The Shah Residence 424 South Columbia

The City of Bexley, Ohio
Board of Zoning and Planning
Request for Certificate of Appropriateness

January 28, 2021

Modifications to Certificate of Appropriateness

Windows

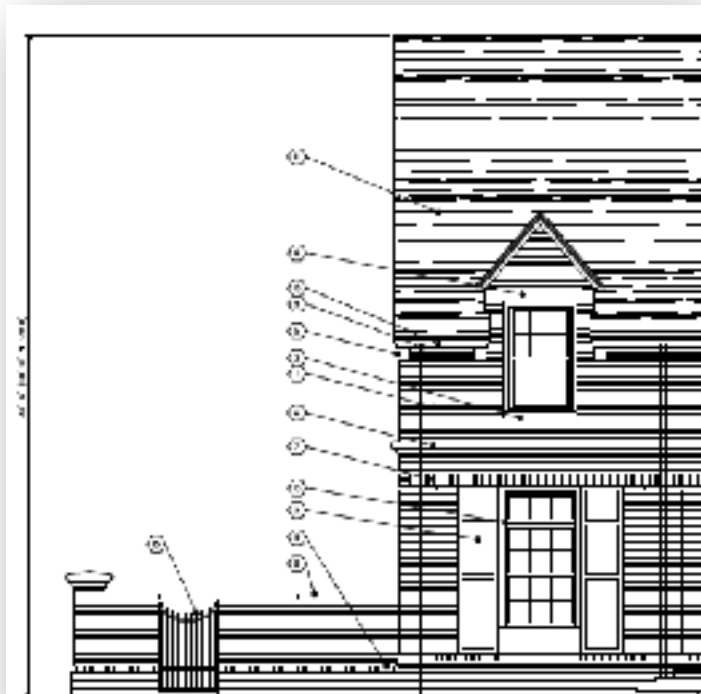
- 6 pane grid on top

- 4 over 4 panes

Height

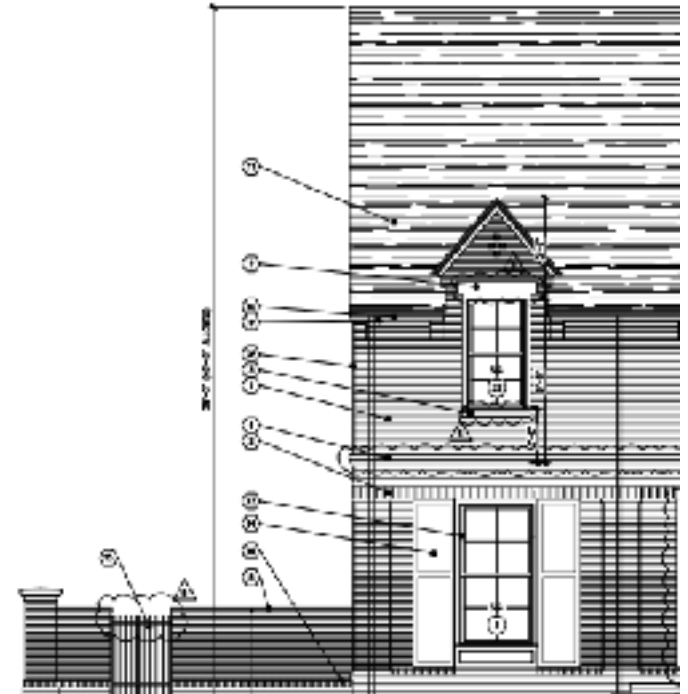
- 36'-6"

- Surveyed at 38'-0"

*Code permits 40'-0"

Garage Door

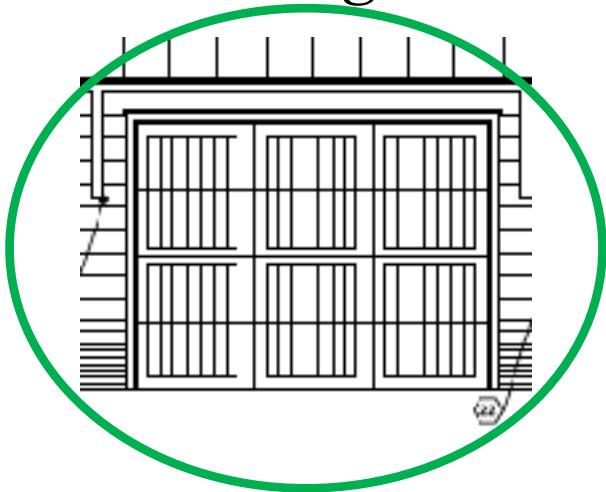
Limited visibility (if any) due to landscaping wall and hedges

Skylights

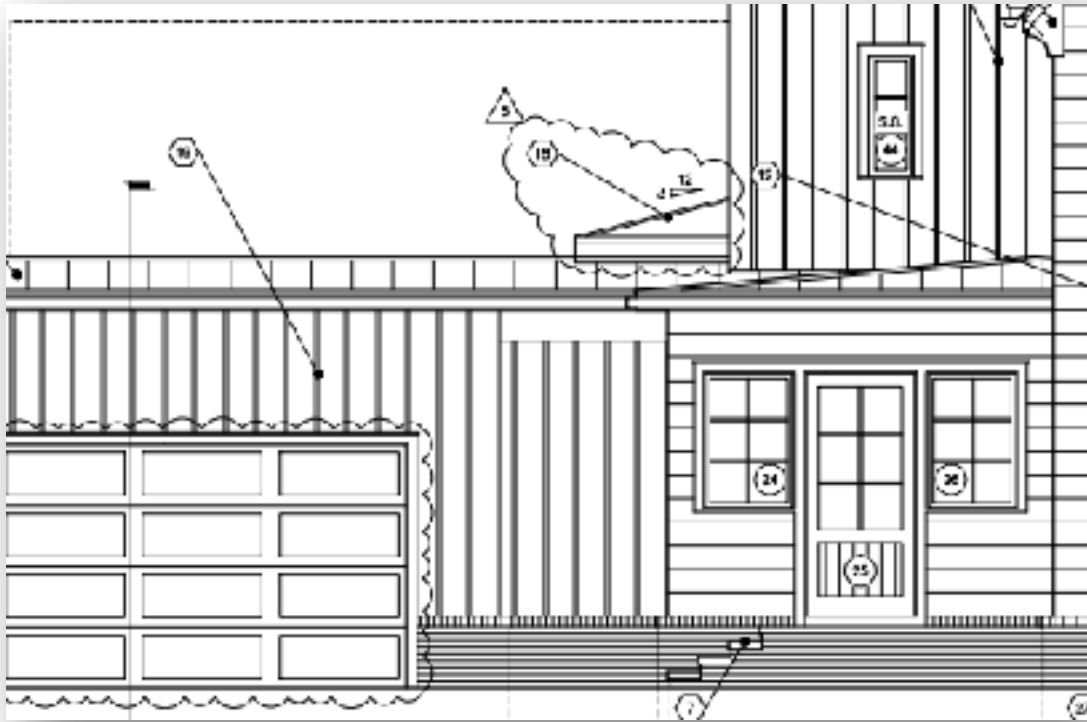
Limited visibility (if any)
